UNITED STATES PATENT AND TRADEMARK OFFICE

APPLICATION NO.	FILING DATE	FIRST NAMED INVENTOR	ATTORNEY DOCKET NO.	CONFIRMATION NO.
10/625,467	07/23/2003	Peter Graf	003-071	9880

Office Action Summary

DETAILED ACTION

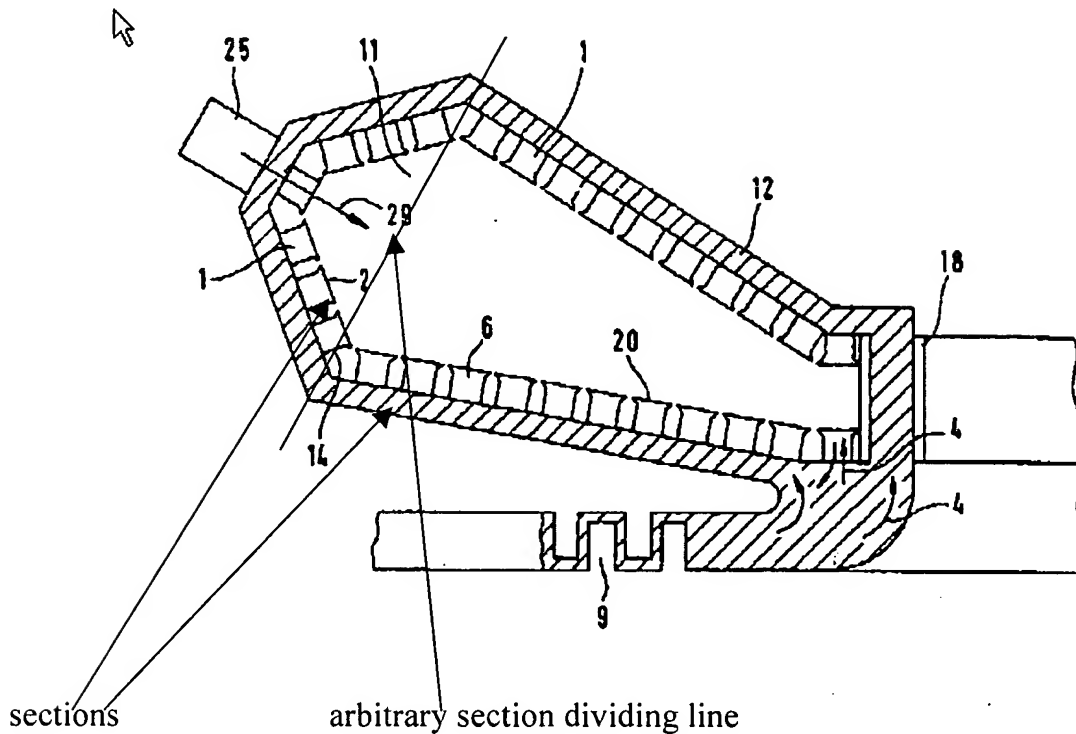
3. Claims 1-9, 11 are rejected under 35 U.S.C. 102(e) as being anticipated by Snyder (2002/0116929). Snyder teaches an annular combustor for a gas turbine, comprising a wall, an inlet side, and an outlet side, the inlet side configured and arranged to accept

burners 76 opening on the inlet side, the combustor extending in an axial direction from the inlet side to the outlet side, cooled liner segments 46, 48, 60, 62 lining sides of the wall for protection from hot gases, wherein the liner segments are subdivided in the axial direction into a plurality of parts arranged one behind the other; wherein the liner segments 46, 48 and 60, 62 are subdivided into two parts; wherein the liner segments are subdivided where the flow velocity of the hot gases is low; wherein the liner segments are subdivided in such a way that the lengths of the individual segment parts in the axial direction are approximately the same; a plurality of segment carriers 50, 44 and 64, 66 the liner segments are fastened to the segment carriers, the segment carriers 50, 44 and 64, 66 are being subdivided in the axial direction into a plurality of parts; wherein the liner segments are convection-cooled (see Fig. 3); wherein the subdivided liner segments are separately convection-cooled; the cooling medium flowing through those parts of the liner segments which are situated downstream, the cooling medium being released into the hot-gas flow of the combustor; wherein parts of the liner segments 48, 62 which are located downstream are cooled only by part of the mass flow provided overall for the cooling of the liner segments; at least burner 76 positioned at the inlet side.
